VOLUME 2 OF 2 - ZONING

Summary of Comments on P:\Projects\1216-00\BIM\Revit \Families\TITLEBLOCKS\EXTELL Proposal_atwalj.pdf

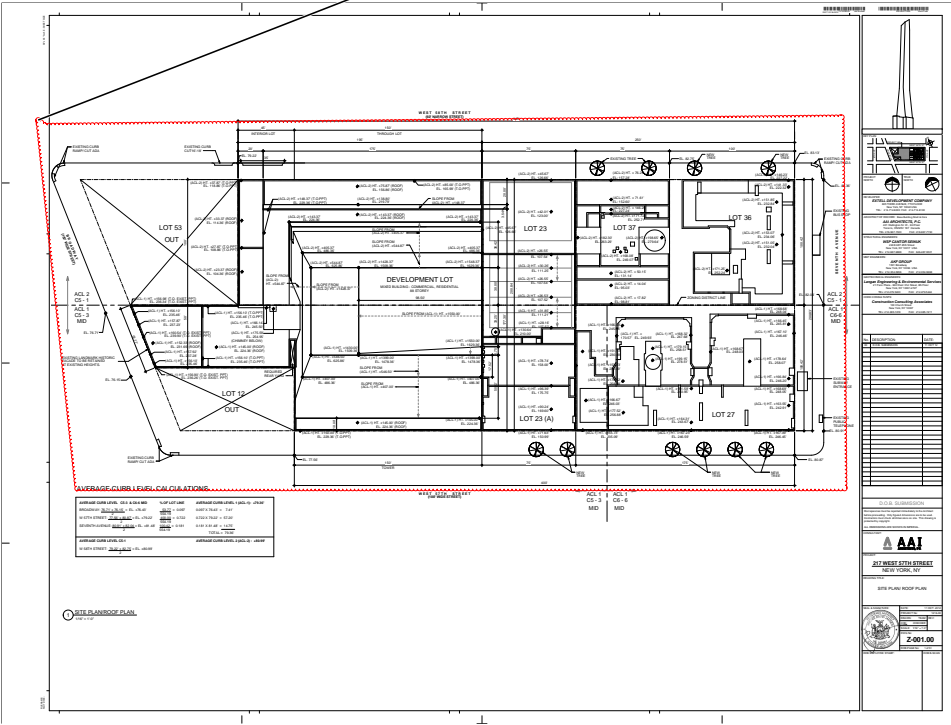
Verify compliance with street tree planting for the entire zoning lot street frontage as per ZR 33-03. Provide ST-1

Transit authority approval if required or provide note on plan "not within 200 feet of TA."

BC 3301
BC 3306 Provide Demolition application

TR-1 for soils – investigations(borings) rec/certif'd; TR-4 Boring report as per BC 1704

Submit a preliminary survey for verification of zoning lot metes and bounds, legal street elevation, street width, fire hydrant, tree location, and adjacent building heights etc.

Author: dtitus Subject: Polygon Date: 1/7/2013 9:09:57 AM
Area indicated is for residential use only with a sq. footage of 1,505.
Fifteen square feet is required per bicycle parking space; commissioner approval is required if submission of a more efficient layout is provided.
(Please indicate in Schedule "A" square-footage with total bicycle parking provided)

Author: dtitus Subject: Polygon Date: 1/4/2013 10:59:34 AM
Provide application for low income housing.

Provide HPD letter. Indicate compliance with inclusionary floor area calculations on zoning floor area schedule to identify compliance with HPD inclusionary housing letter.

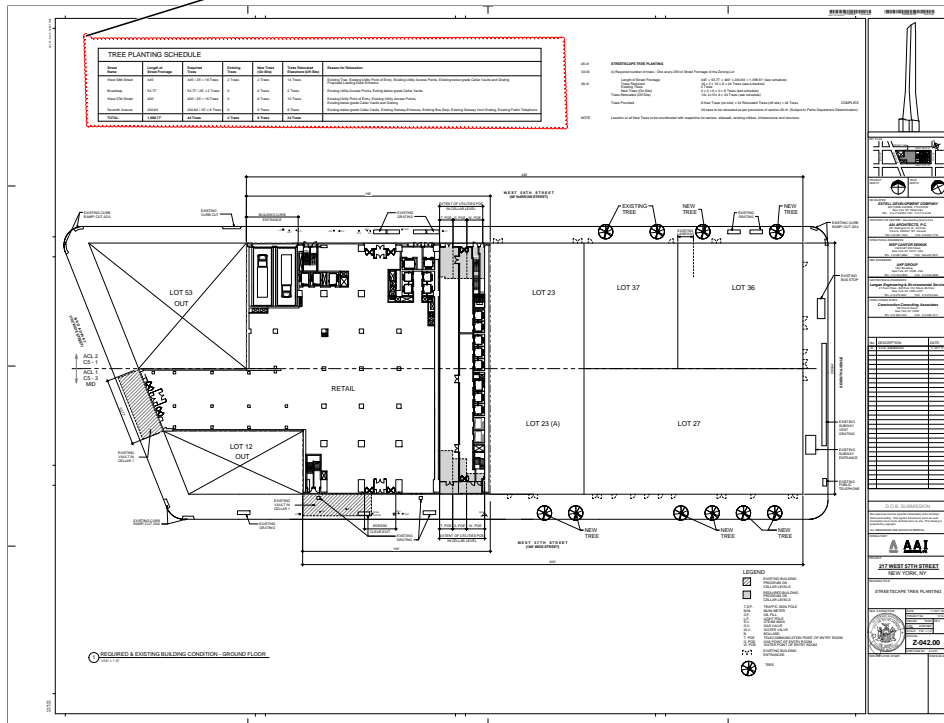
Please clarify deductions taken within stair inclosure. **TYP all floors.**
8" for the stair perimeter, not sure what the additional 60+ sq. ft. is for per floor. ARCH/MH dwgs does not indicate any shaft enclosures within stair.

Mech. plan was not provided for this floor. 31st FL.

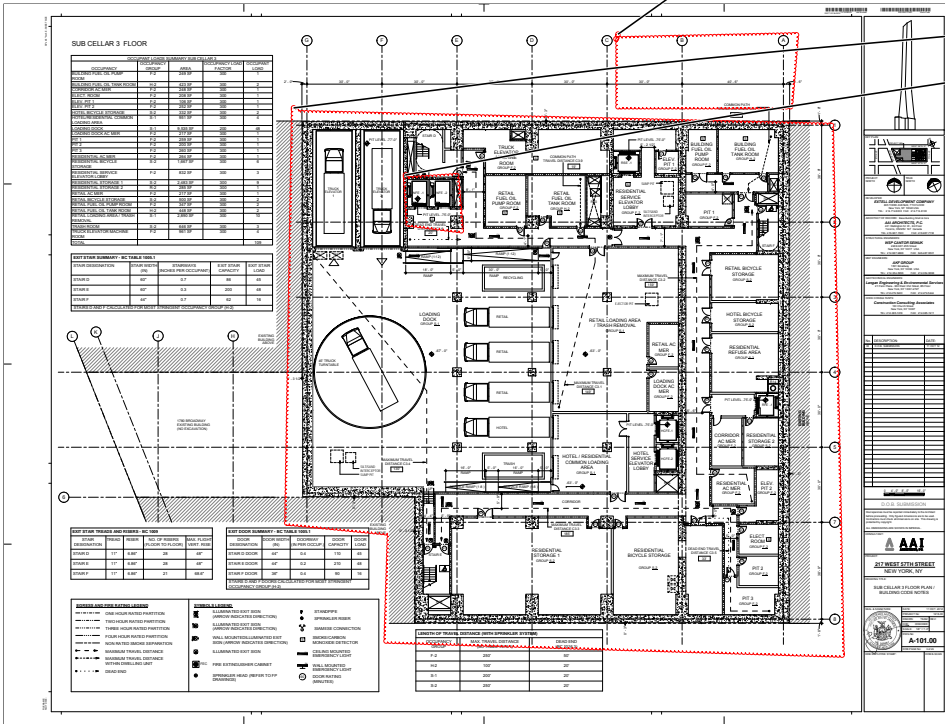
TABLE 403.1 Provide table for plumbing fixtures to comply with table. 403.1. Provide calculations within each space, etc. and show layout to verify compliance to BC 1101.2; ICC/ANSI A117.1-2003

All nonresidential facilities to comply with BC 1109.

Show all grab-bars including vertical

Required clearance around the water closet to comply with ICC/ANSI 2003 604.3

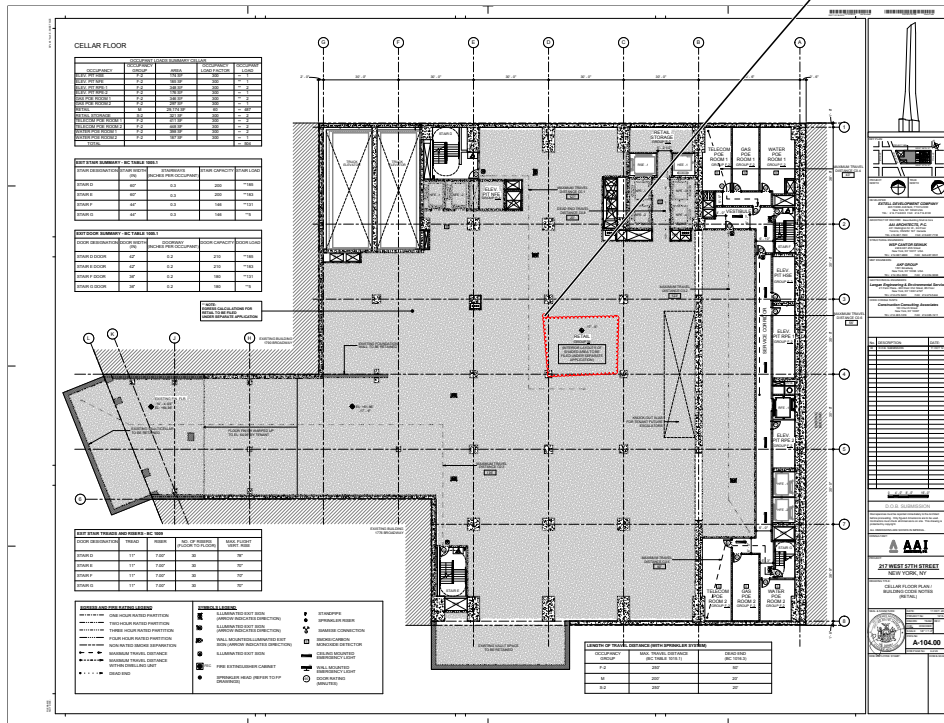
All nonresidential facilities to comply with BC 1109.

Show all grab-bars including vertical

Required clearance around the water closet to comply with ICC/ANSI 2003 604.3

Author: dtitus Subject: Polygon Date: 1/2/2013 12:52:48 PM
Provide curb cut details with plans and sections.

Location of proposed curb cut is contrary to section BC 406.7.6 (3). This is not a corner lot and a minimum separation of 8'-0" is required from side lot line.

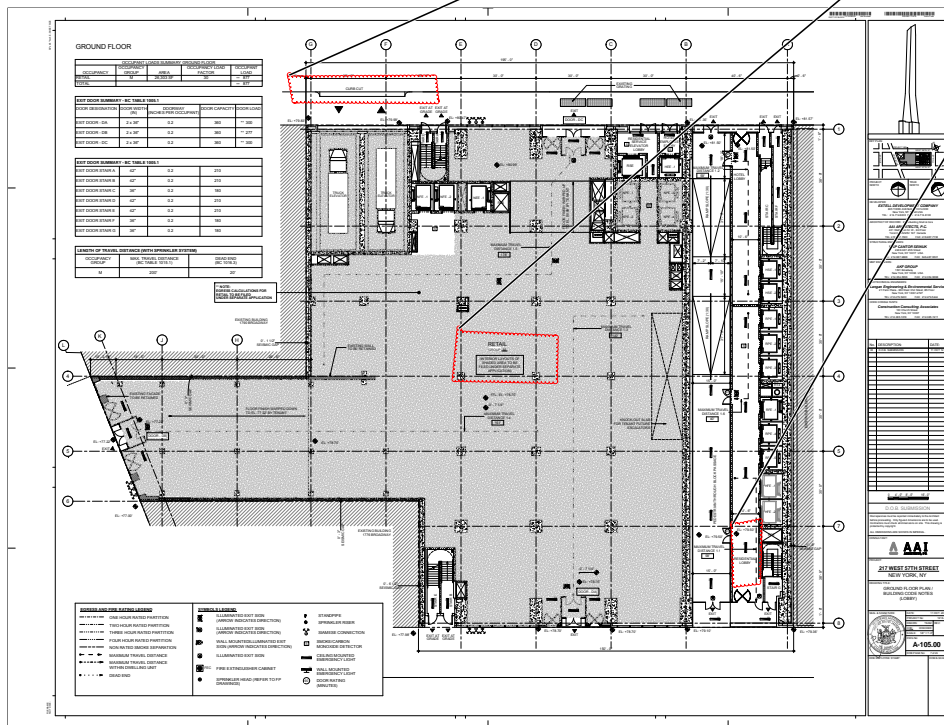
Show all grab-bars including vertical

Required clearance around the water closet to comply with ICC/ANSI 2003 604.3

Provide note to verify compliance with BC 1008.4.1; 1008.4.2; 1008.4.3; 1008.4.4.

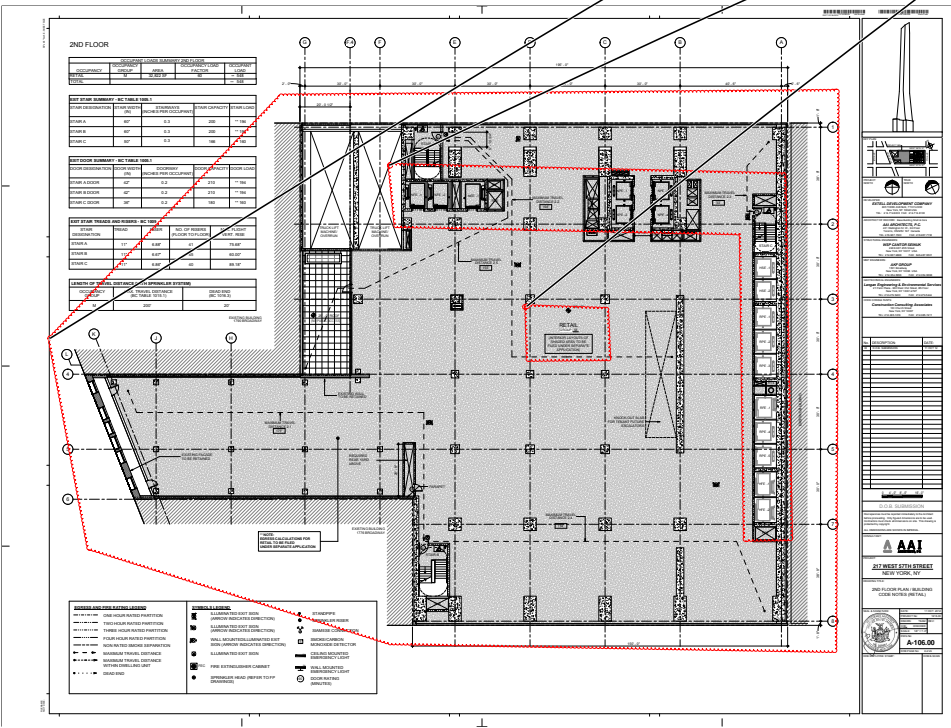
BC 1910, LL 17/95 **Earthquake**
state on plan and show compliance with LL 17/95;
separation (1" per 50 ft. height); (compliance must be verified on A & ST floor plans)
earthquake code applicability & pounding notes;

Author: dtitus Subject: Polygon Date: 1/7/2013 9:28:30 AM
Elevator to accommodate 24"x76" ambulance stretcher (BC 3002.4).

Author: dtitus Subject: Polygon Date: 1/7/2013 9:35:40 AM
TABLE 403.1 Provide table for plumbing fixtures to comply with table. 403.1. Provide calculations within each space, etc. and show layout to verify compliance to BC 1101.2; ICC/ANSI A117.1-2003

Provide exit lighting and directional signs (lighting) & (egress) as per BC 1006, BC 1011, BC 1026 (both EG and Construction plans)

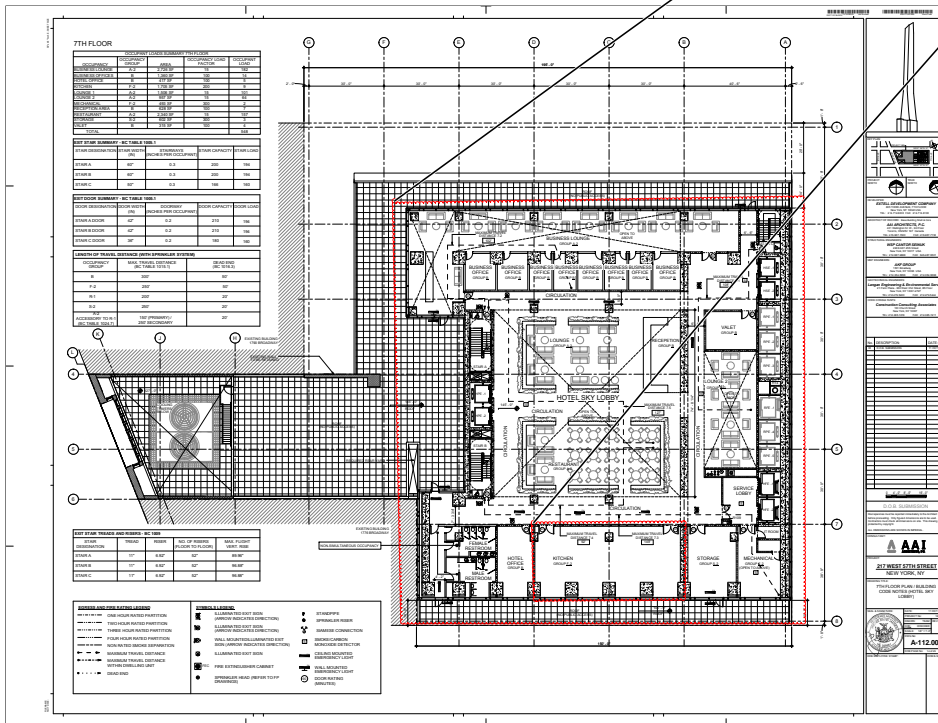
BC 903.2.12.2 Commercial cooking operations. An automatic sprinkler system shall not be installed in a commercial kitchen exhaust hood and duct system. Fire extinguishing systems shall be installed in commercial cooking systems in accordance with Section 904.11.

BC 904.2.1 Hood system suppression. Each required commercial kitchen exhaust hood and duct system required by the *New York City Fire Code* or the *New York City Mechanical Code* to have a Type I hood shall be protected with an approved automatic fire-extinguishing system installed in accordance with this code.

Kitchen shall also comply with MC 506, 507, and 508; PC 802.1.7 and 1003.3.1. Please verify on MH/PL plans.

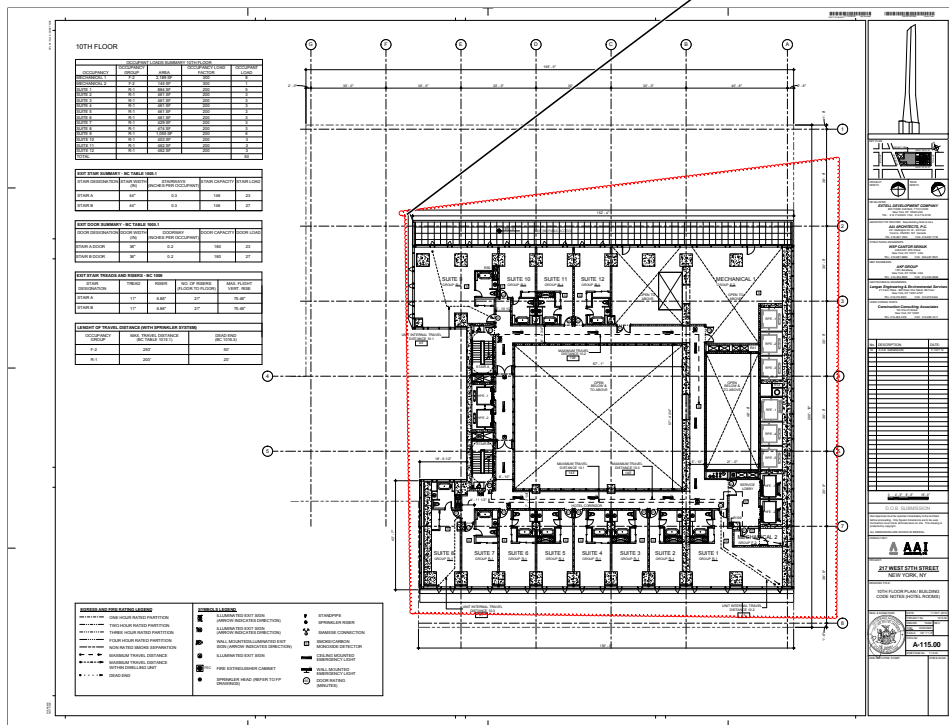
The common path of egress travel shall not exceed 125 feet as per BC 1013.3. The maximum length of exit access travel, measured from the most remote point within a story/space to the entrance to an exit along the natural and unobstructed path of egress travel, shall not exceed the distances given in BC Table 1015.1.

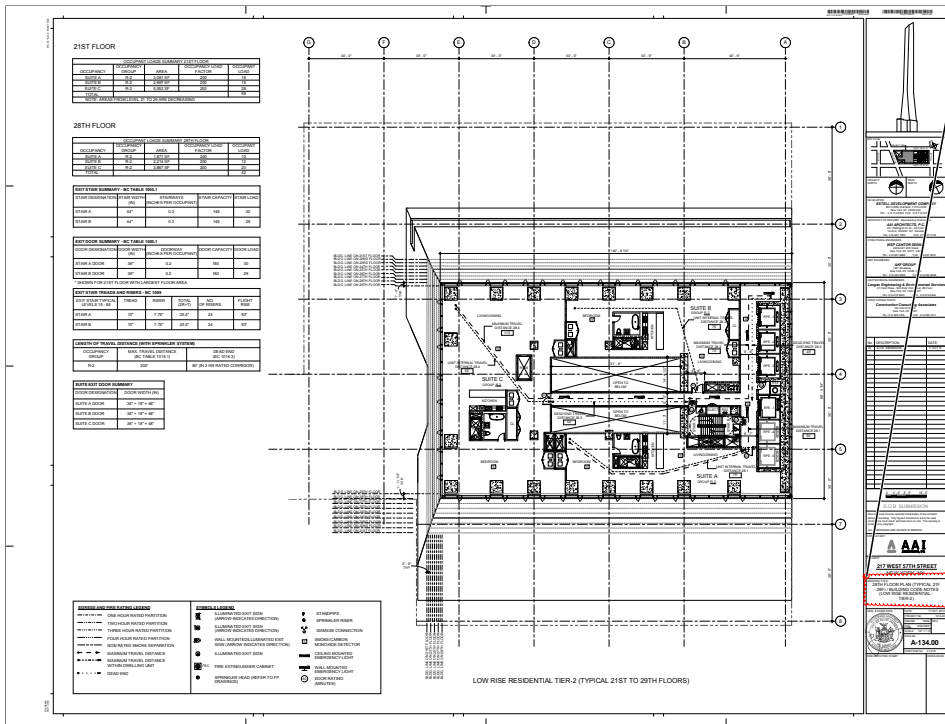
Author: dtitus Subject: Polygon Date: 1/7/2013 9:31:18 AM
The common path of egress travel shall not exceed 125 feet as per BC 1013.3. The maximum length of exit access travel, measured from the most remote point within a story/space to the entrance to an exit along the natural and unobstructed path of egress travel, shall not exceed the distances given in BC Table 1015.1.

Author: dtitus Subject: Polygon Date: 1/7/2013 9:30:14 AM
BC 908.7.1.2 Provide notes to indicate compliance for carbon monoxide detectors.
Indicate location of smoke/ carbon monoxide detectors. (TYP.)

Author: dtitus Subject: Polygon Date: 1/4/2013 10:06:27 AM
Provide refuse chute details: [2 hr fr walls & roof] and compliance with BC 1213.3 and BC 707.13
Refuse storage room to comply with BC 1213.1
Provide proper enclosure and details
Provide UL # for system or fire hopper doors
Compliance with BC 1101.2;

Author: dtitus Subject: Polygon Date: 1/4/2013 10:41:39 AM
Provide note describing stairway door operation and stairway communications system as per BC 403.12
Provide note describing smoke proof exit enclosures for compliance with BC 403.13.
Provide note describing impact-resistant stairs enclosures as per BC 403.15
Provide exit lighting and directional signs (lighting) & (egress) as per BC 1006, BC 1011, BC 1026 (both EG and Construction plans)

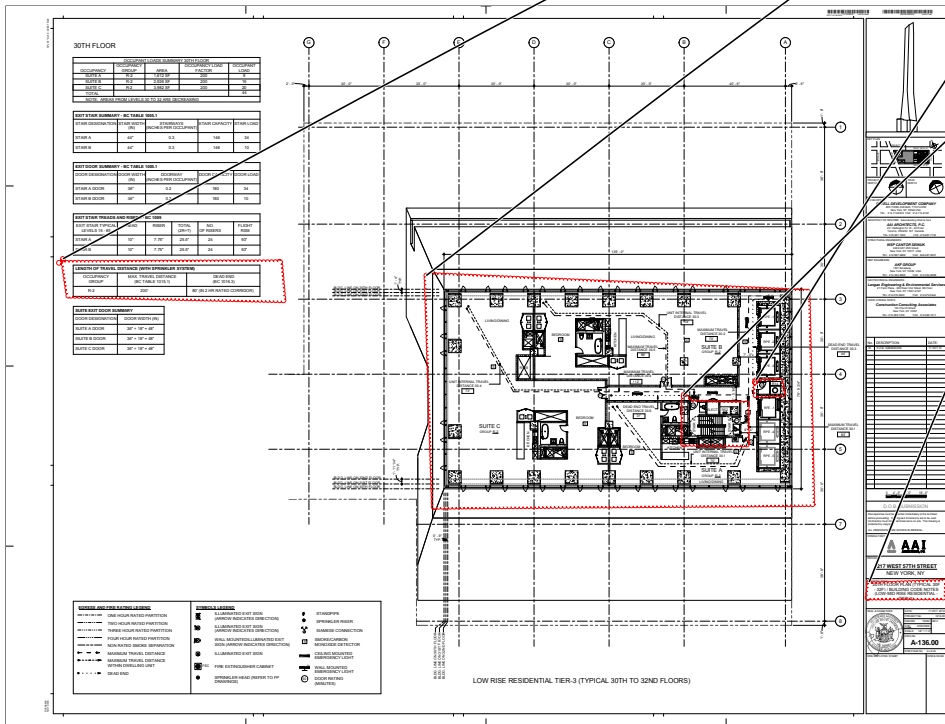
Author: dtitus Subject: Polygon Date: 1/4/2013 10:05:14 AM
Please indicate as Typ. 30-32nd Floor Plans

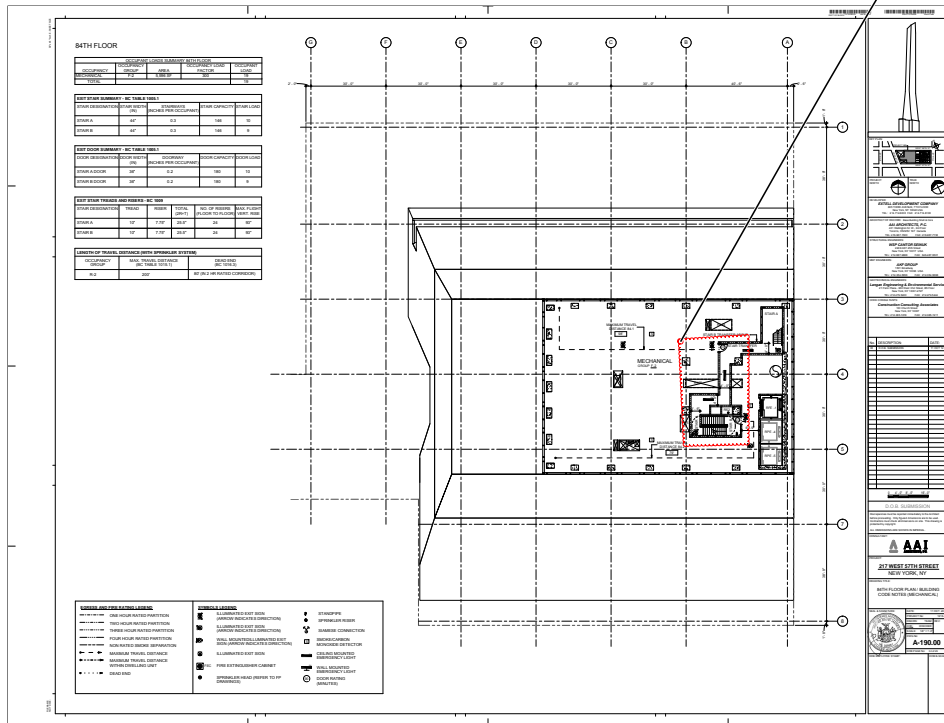
Provide fire protection of openings in exterior walls (BC 704.8, BC 705.8, BC 715.4).

BC 403.11.1 Emergency power systems for *assembly* occupancy

1. Exit signs and means of egress illumination required by chapter 10;2.
3. emergency voice communications systems; and
4. Electrically powered fire pumps, unless electrical power to the motor is taken ahead of the main from the street side of the service switch.

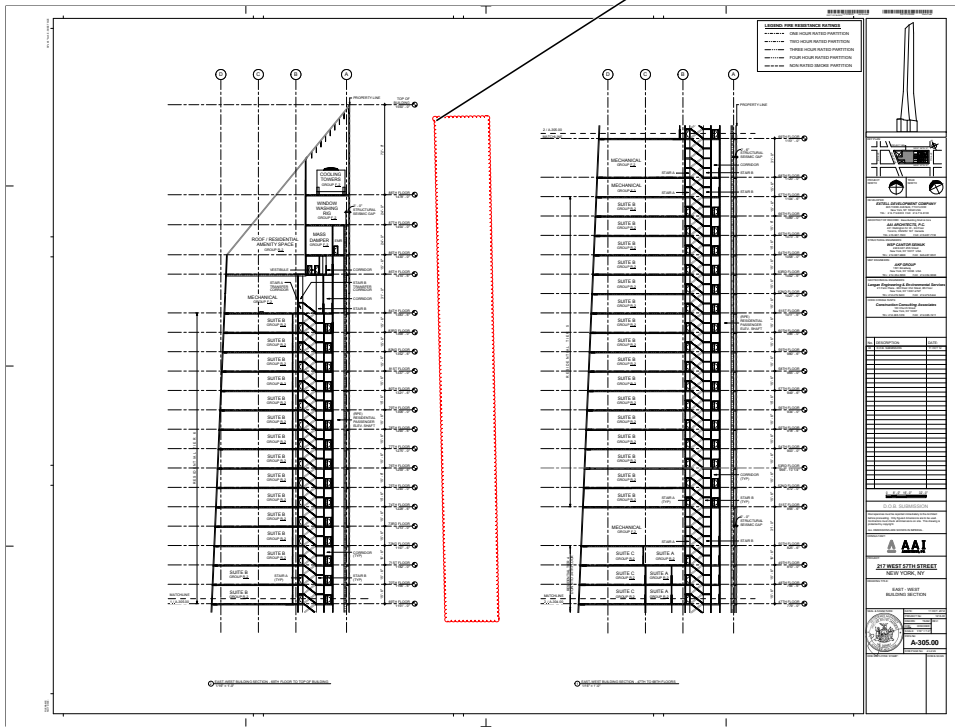
Author: dtitus Subject: Polygon Date: 1/2/2013 11:59:00 AM
All interior stairs must lead to the roof as per BC 1009.12

Provide all schedules windows, doors (indicate FPSC on all fire rated doors) etc.

Provide structural peer review report as per BC 1627.

Summary of Comments on FP-401.00

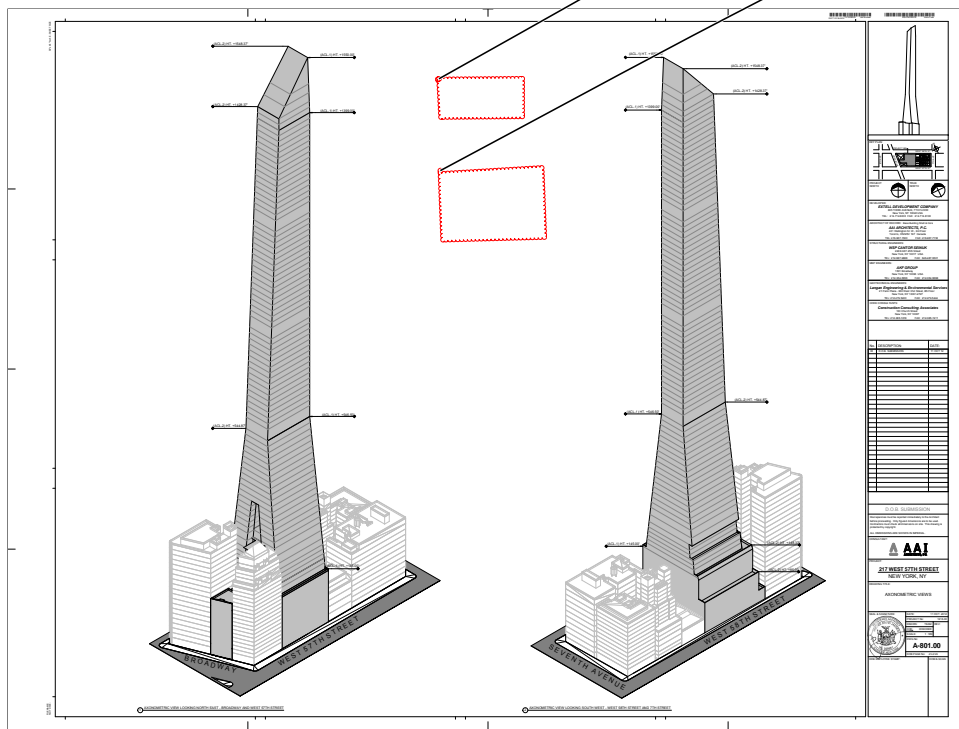
Provide building elements, exterior walls of non-combustible construction with fire-resistance ratings for Type I-B construction (BC 602.1, BC 602.2).

Author: dtitus Subject: Polygon Date: 1/8/2013 9:12:55 AM
Please provide a complete water and gas riser diagram.
